Dublin Cycling Campaign

30 August 2022

Blanchardstown to City Centre Core Bus Corridor (Case: 313892)

Figure 1 Blakestown Rd Junction showing no car slip lane in final public consultation round.

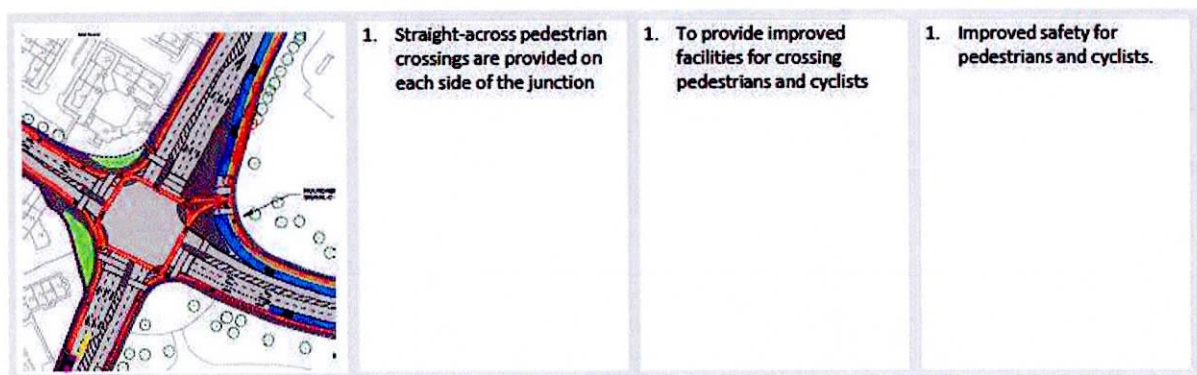
For example, "*TIA Sub Appendix 2 - Junction Design Report*" shows the design evolution of the Blanchardstown Road South / Blakestown Way junction (general arrangement drawing sheet 4). The July 2021 iteration re-adds a left-turn slip for general traffic in order to improve junction capacity for motor traffic (as shown in Figure 1 below).

Proposed vehicle slip lanes, where vehicles can cut across people cycling, sometimes at relatively high speeds, are proposed once again, particularly in the Blanchardstown area. None of the junctions around Blanchardstown reflect any of the four junction types developed in the '*Preliminary Design Guidance Booklet for BusConnects Core Bus Corridors (PDGB) (NTA 2021)*' in Appendix A4.1. This issue of inappropriate slip lanes has been raised through the various iterations of this scheme, and yet remains to be comprehensively addressed.

DMURS 4.4.3 states that designers "*should omit left-turn slips as they encourage high traffic speeds and are highly disruptive for people walking and cycling*". As per the present [National Cycle Manual](#) Section 7.8, the vehicle slip lanes should be removed, particularly at this location in the context of a major town centre.

Figure 2 Excerpt from Appendix A6.3 Junction Design Report showing Blakestown Rd Junction final design with additional slip lane

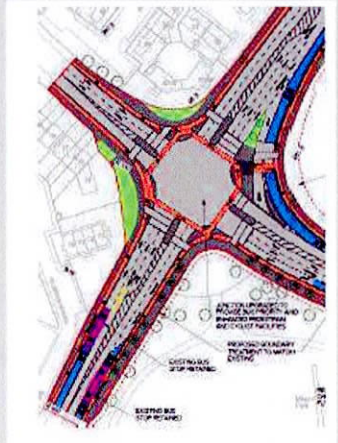
Note the conflicting rationale stating the addition of a vehicular slip lane brings the junction into line with BusConnects PDGB principles. As stated previously, none of the junction types outlined in PDGB recommend slip lanes.
